Responses to USEPA TSCA-Related Questions

NEW BEDFORD MARINE
 COMMERCE TERMINAL
 AREA FOR TSCA
 DETERMINATION

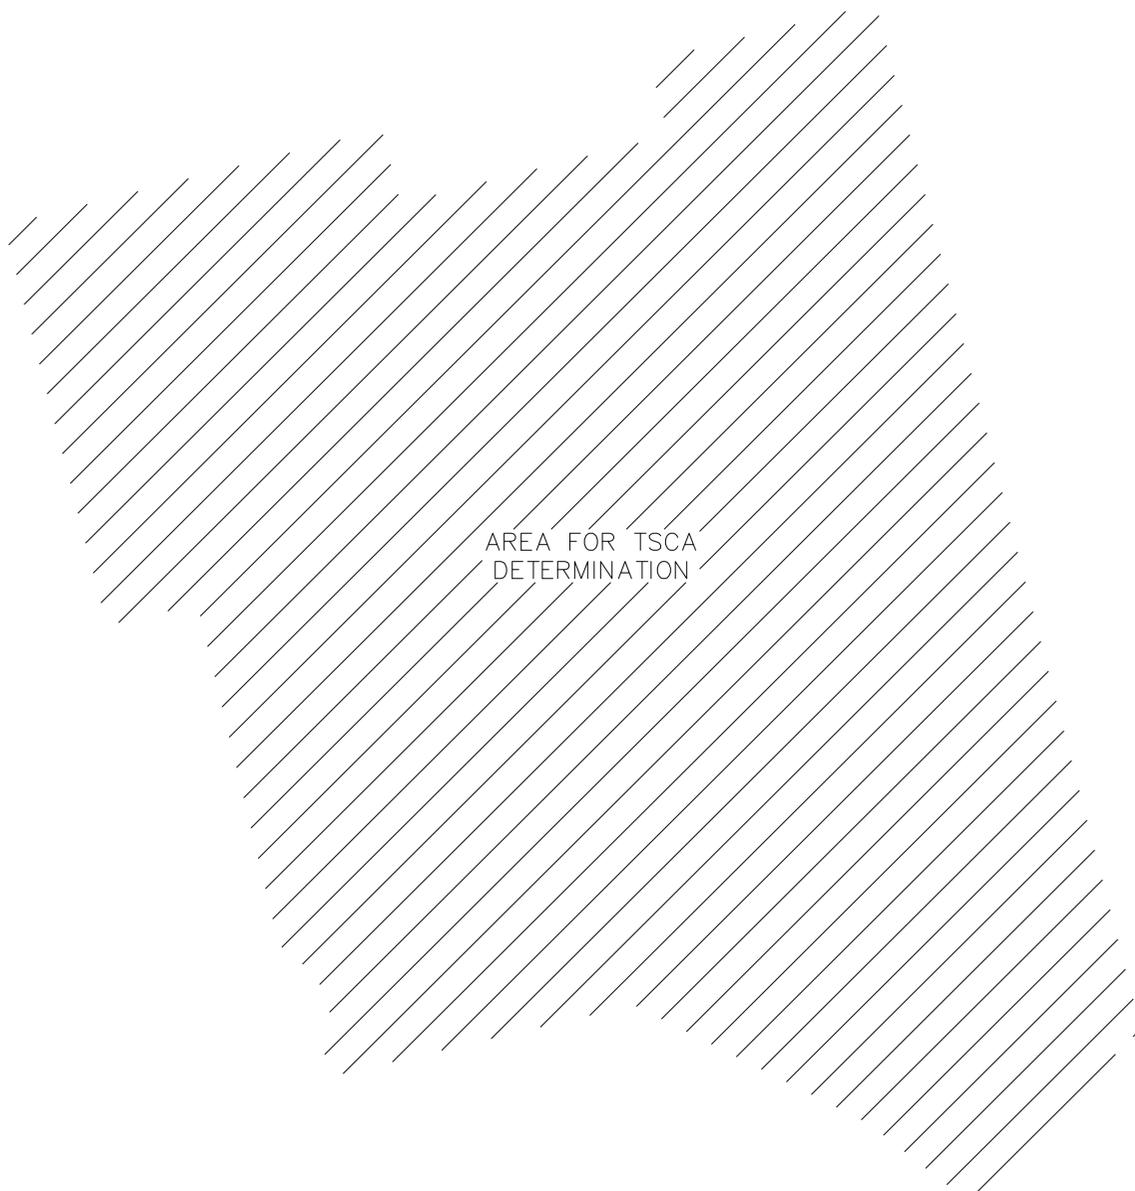
2. **Question:** What are the proposed boundaries of the TSCA upland determination for the New Bedford Marine Commerce Terminal?

- **Place a deed restriction over the area within which a TSCA determination will be issued.** The Commonwealth proposes instituting a deed restriction to limit future use of the area within which a TSCA determination will be issued (see attached Figure) to commercial or industrial activity. The deed restriction will also manage future excavation at the site to control risks to potential future workers and occupants. It is anticipated that this restriction will likely be instituted as an Activity and Use Limitation under the Massachusetts Contingency Plan.

Response: The proposed boundaries are shown in the attached **Figure**.
